NL-20-070

Subject: Response to Requests for Additional Information - License Amendment  
Request to Revise the Indian Point Nuclear Generating Unit No. 3  
Licensing Basis to Incorporate the Installation and Use of a New Auxiliary  
Lifting Device

Indian Point Nuclear Generating Unit No. 3  
NRC Docket No. 50-286  
Renewed Facility Operating License No. DPR-64

**Response to Requests for Additional Information**

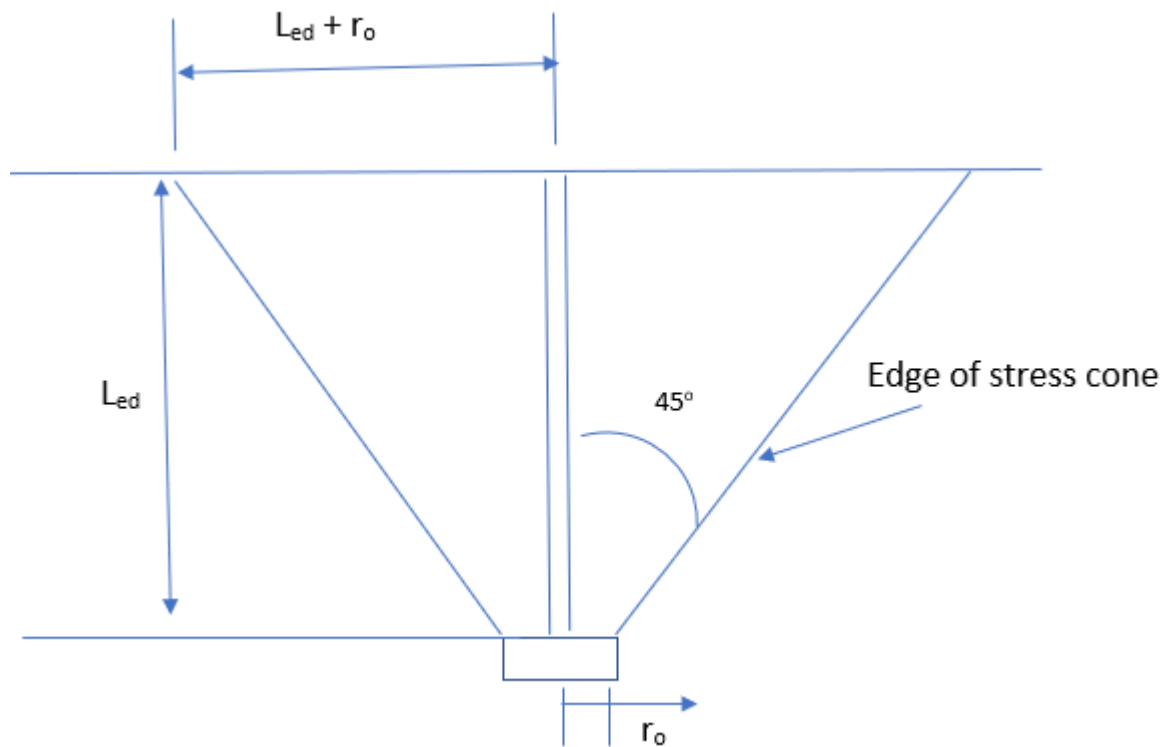
**Issue:** While reviewing the sample calculation provided in Appendix E, the NRC staff was unable to determine whether or not the licensee considered anchor behavior effects under loads such as embedment size (overlapping), edge distance, prying, etc., per the requirements of ACI 349-85 standard in the calculations. Otherwise, the load-carrying capacity of anchors may be overestimated without the consideration of these anchor behavior effects under loading.

The NRC staff is requesting the licensee to describe whether the anchor behavior effects under loads, per the requirements of ACI 349-85, were considered in the calculations. If not, the licensee is requested to either provide justification for not considering anchor behavior effects or to revise the anchor calculations as necessary.

The applicable anchor behavior effects such as cone overlapping and edge distances are appropriately considered in the HI-2188625, Appendix E calculations.

Note: All anchor evaluations performed in Appendix E are based on the anchor patterns and dimensions from Appendix G of HI-2188625 and Holtec Drawing 11654. Once the

final as-built anchor configurations are available, the anchor evaluations will be appropriately updated as needed to account for anchor size, dimensions, material, embedment depth, anchor spacing, edge effects and other factors as applicable by the code.

$h_{ef}$  is the minimum embedment depth (i.e. 18 inches per Appendix E of HI-2188625)

$c$  is the minimum edge distance (i.e. 18 inches per Appendix E of HI-2188625)

$s$  is the anchor spacing (i.e. 24 inches per Appendix E of HI-2188625)
